### DESIGN REVIEW BOARD COMMENT LETTER

Site Address: 1051 Mission Road - PUC site

Project No.: P18-0081: UP19-0008 & DR19-0028

**Conditions of Approval**  
**P18-0081: UP19-0008 & DR19-0028**  
**1051 Mission Road**

Figure A - Building B – All Floors

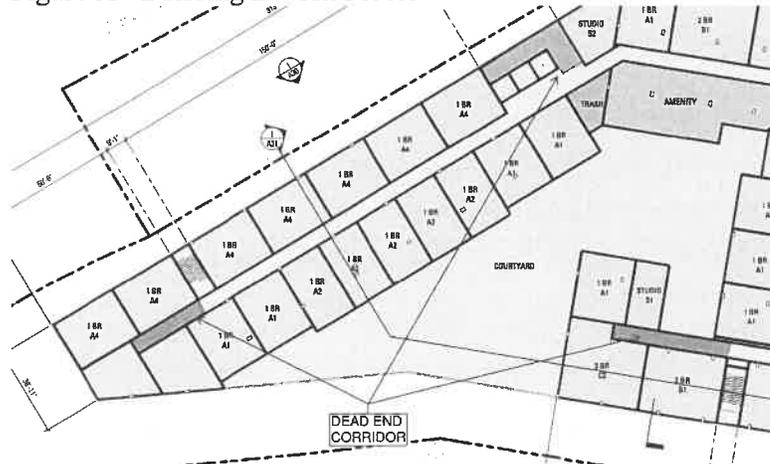
- a) All Buildings:
  - i) Ensure dead end corridors do not exceed 50 feet. CBC 1020.4. See figures below for example.
